SHIRE OF DENMARK

Special Council Meeting

MINUTES

5.1 STRUCTURE PLAN – LOT 621 HARLEQUIN STREET AND LOT 1 SOUTH COAST HIGHWAY, DENMARK

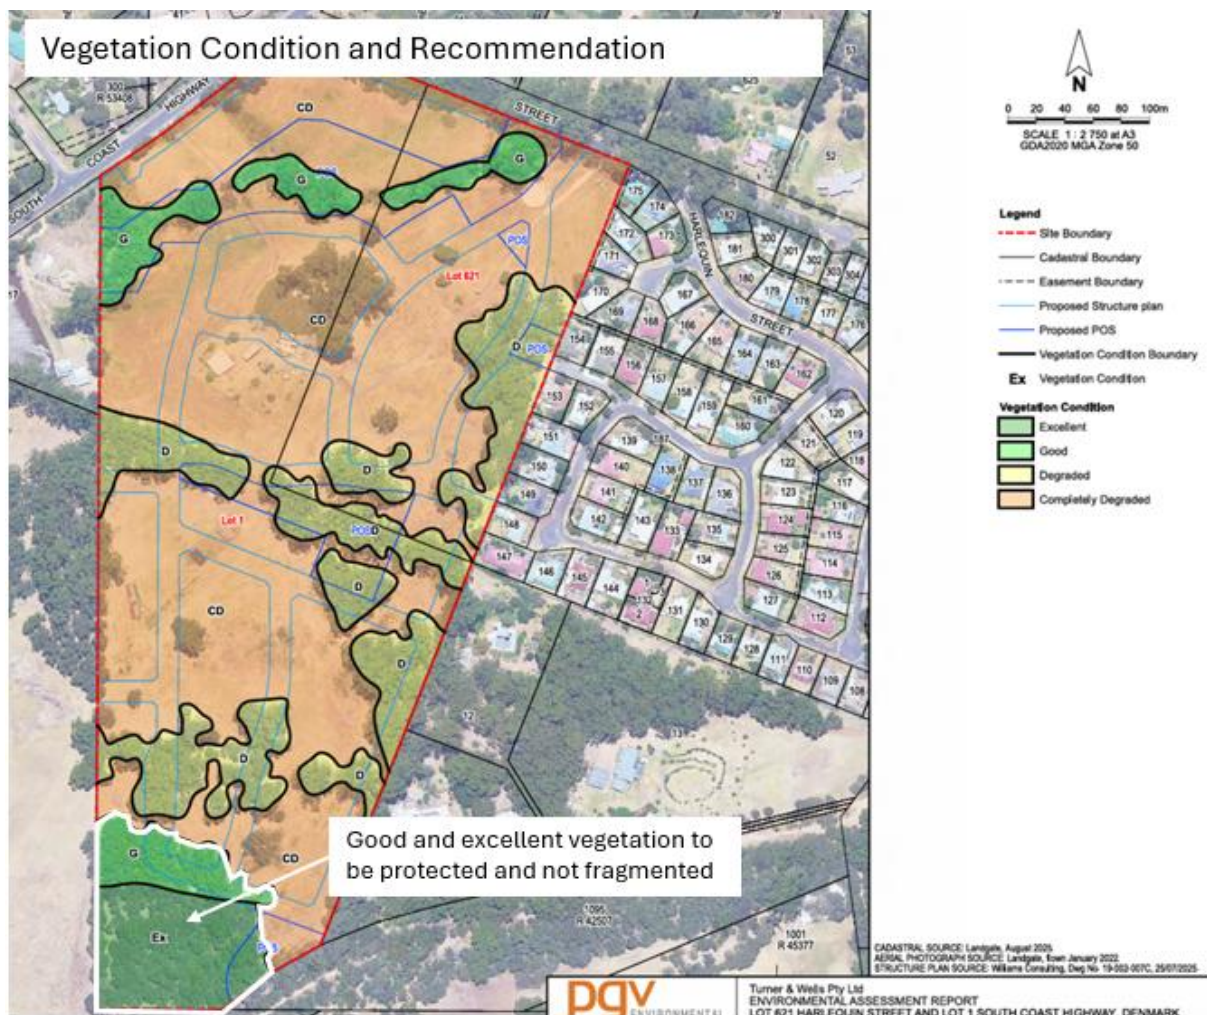
29. Larger lot sizes can support the retention of existing vegetation, and the use of building envelopes can help direct development away from significant trees. However, achieving meaningful tree retention on private lots requires careful subdivision-stage coordination to ensure the lot size and shape, proposed lot boundaries, mapped Tree Protection Zones and building envelopes are mutually consistent and enforceable.

30. The area to the south, identified as good to excellent condition with high fauna habitat value, is proposed to be subdivided into larger lots. This approach will result in significant fragmentation of high-quality remnant vegetation due to clearing associated with dwelling construction, asset protection zones, Bushfire Attack Level (BAL) compliance and requirements under the Shire's annual Firebreak and Property Management Notice and is not supported.

31. This outcome is contrary to EPA advice and Local Planning Scheme No. 3 provisions, which seek to retain areas of significant environmental value in a consolidated and secure manner.

32. The original recommendation tabled at the April OCM was that the Structure Plan be modified to comply with EPA's advice and LPS3 provisions, by retaining the area within public open space for conservation purposes.
33. Following further assessment and the proponents' concerns around this matter, other options have been considered. Various planning mechanisms can be applied to protect vegetation in good to excellent condition along the southern boundary of the subject land. As such, this area does not necessarily need to be secured as a POS to protect the vegetation community. It is recommended that this area be identified as a 'vegetation protection area' to be retained and protected through an appropriate planning mechanism, such as a Local Development Plan.

Significant Tree Retention (Diameter > 500mm)

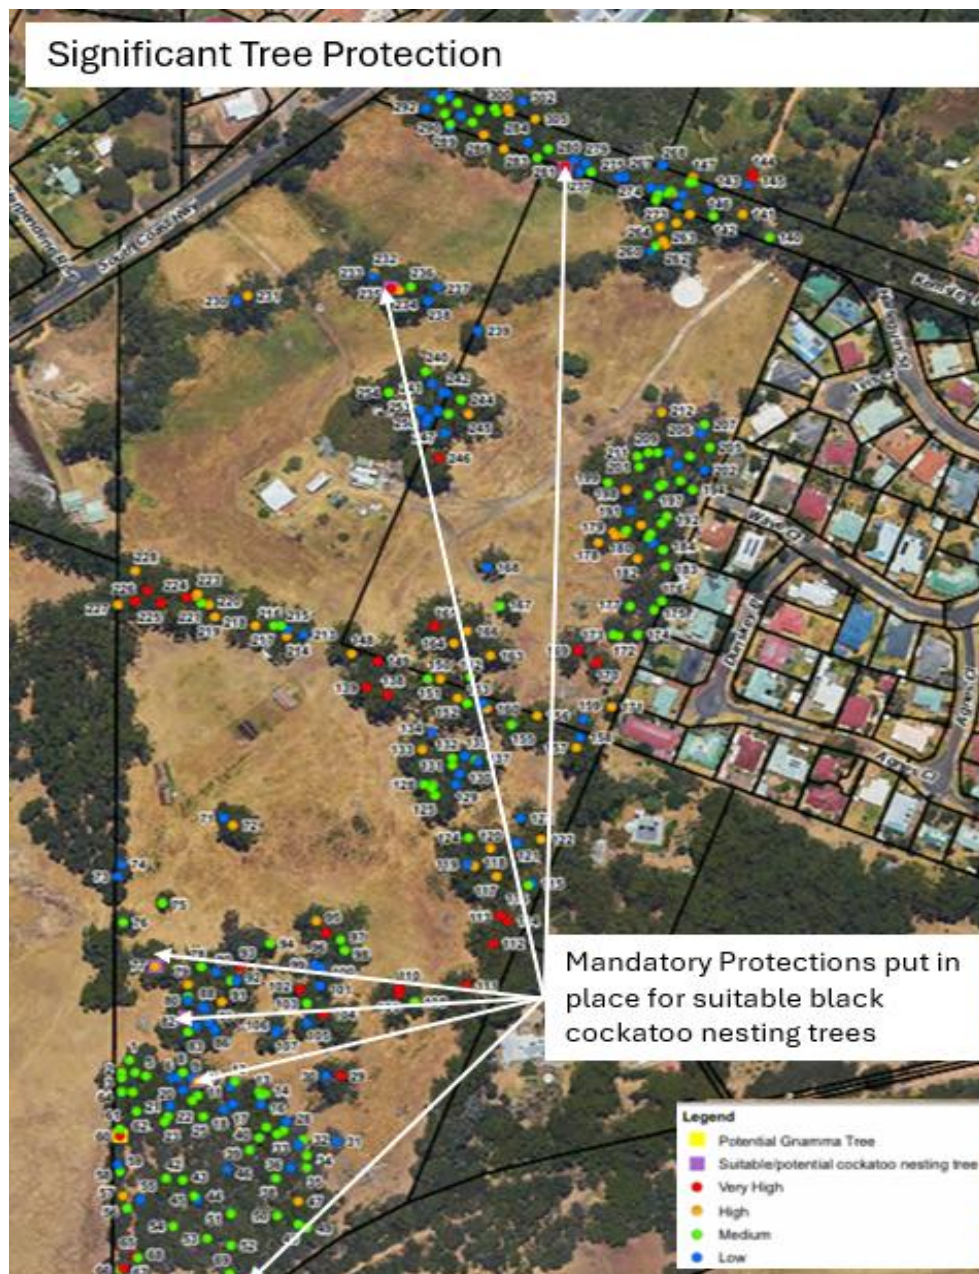
34. A significant number of trees are proposed to be retained in future lots. The Structure Plan proposes that an agreement be entered into with the Shire of Denmark to apply a Restrictive Covenant on Title protecting selected trees
35. The size of lots (R20) currently shown over areas of remnant vegetation which has been identified as Black Cockatoo/fauna habitat may not in all cases result in sufficient land area to accommodate both a building envelope and retention and protection of trees. It is recommended that the Structure Plan be modified to show

how trees are proposed to be protected within private lots and that tree protection zones and building envelopes be identified at the subdivision stage.

36. The proposed restrictive covenants on title as a statutory mechanism to protect the trees on private lots may not represent the most suitable or robust long-term protection mechanism due to monitoring and enforcement resources required by local government. Additional/alternative mechanisms may include the use of existing Scheme provisions requiring approval for tree removal and a local planning policy on tree retention.

Assessment of Liveable Neighbourhoods: Public Open Space

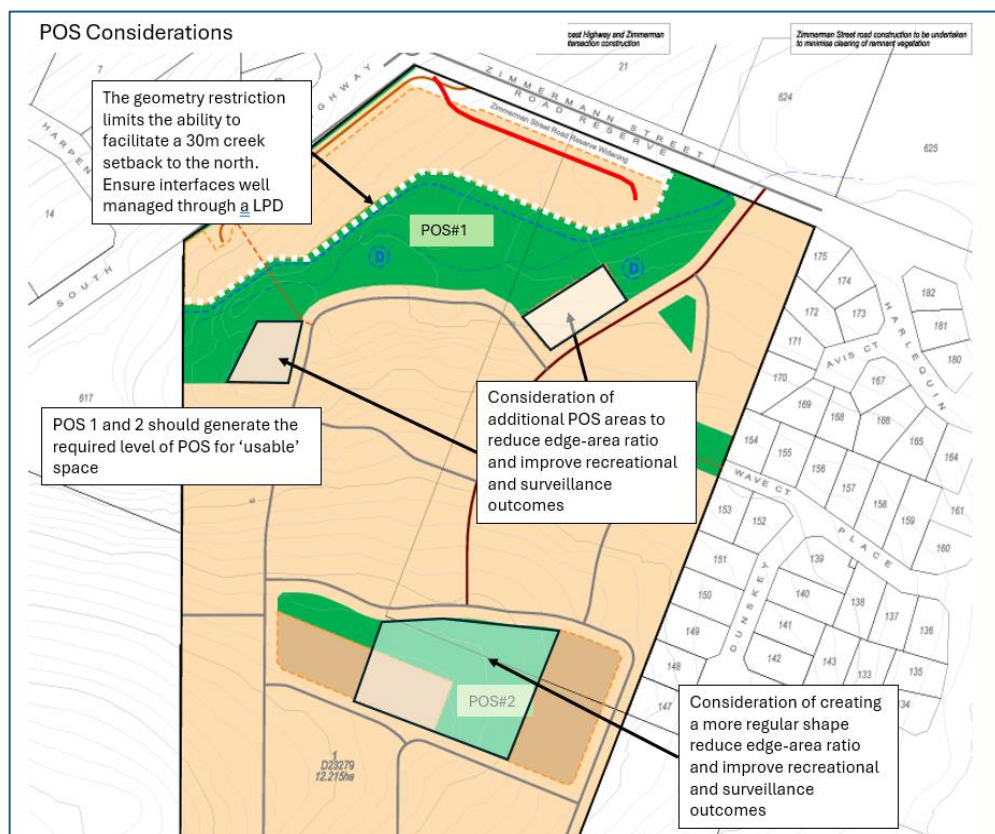
72. The extent to which drainage infrastructure (including detention basins/sumps) will reduce the area of usable parkland in POS 1, is not clearly demonstrated at the Structure Plan stage. This creates a reasonable perception that POS is being treated as secondary to drainage infrastructure, rather than being planned as a valued public place. While integrating stormwater management within POS can be supported where appropriately designed, this is only acceptable where recreational value, accessibility and safety are clearly retained and the drainage function does not dominate the public space.

77. Deferring the achievement of good POS outcomes to future Local Development Plans (LDPs) is not supported. LDPs can refine built form and interface treatments at the lot level, but they cannot rectify fundamental structure plan issues such as the location, width, shape and usability of POS. Quality POS is expected to be planned and secured through the structure plan and subdivision design.

78. The Structure Plan identifies that it meets the minimum 10% POS contribution requirement under the Liveable Neighbourhoods. However, the 10% standard is a minimum provision, and does not, on its own, demonstrate that the POS is of acceptable quality and usability. Local governments may reasonably seek additional or improved POS outcomes where site and local circumstances warrant it.

79. Taken as a whole, the current POS network prioritises subdivision efficiency and servicing outcomes over community benefit. In its current form, the POS system cannot be considered an appropriate or equitable public open space contribution, as it does not clearly demonstrate usability, safety, high-quality interfaces or a coherent recreation function consistent with the Shire's and State policy intent. It is therefore recommended that the Structure Plan be modified to incorporate POS areas that demonstrably meet the design objectives of both the Shire's Local Planning Policy 39: Public Open Space and Liveable Neighbourhoods.

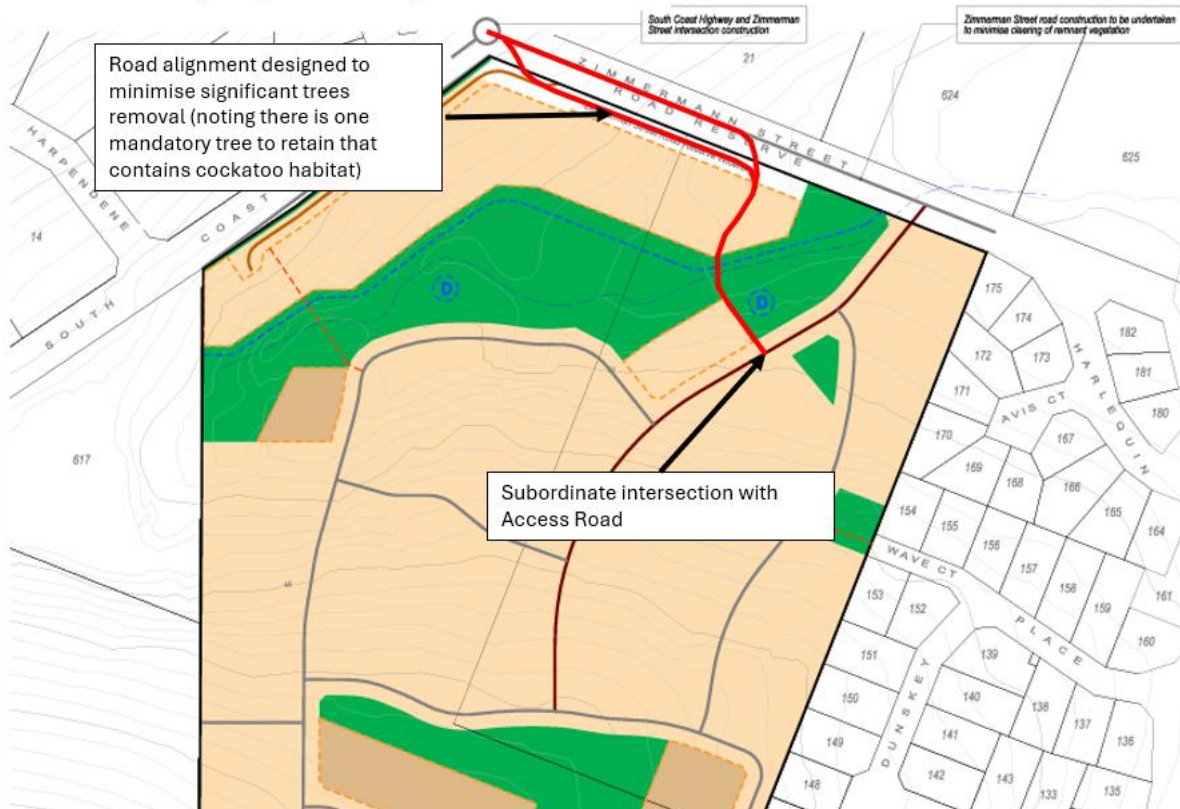
95. The applicant seeks to retain access to the subject land via the Zimmerman Street road reserve. The rationale for this appears to be:

- That the road reserve width and topography at the previously recommended site at a mid-point between Ross Court and Harpendene Rise would not facilitate a passing bulge resulting in a difficult and expensive intersection.
- The Zimmerman Street alignment would make a more attractive entry to the future subdivision in either a boulevard approach with retained trees through the centre aisle or the road along the western edge of the existing vegetation.

96. Main Roads originally objected to the access road alignment in the advertised structure plan due to the creation of a through road/shortcut to Ocean Beach Road, increasing traffic impacts on South Coast Highway, the Kemsley Estate community and Ocean Beach Road.

97. It is accepted that shifting the access road to the mid-point between Ross Court and Harpendene Rise is not the only way of addressing the concerns raised during advertising and assessment of the structure plan. Having regard to the objection from
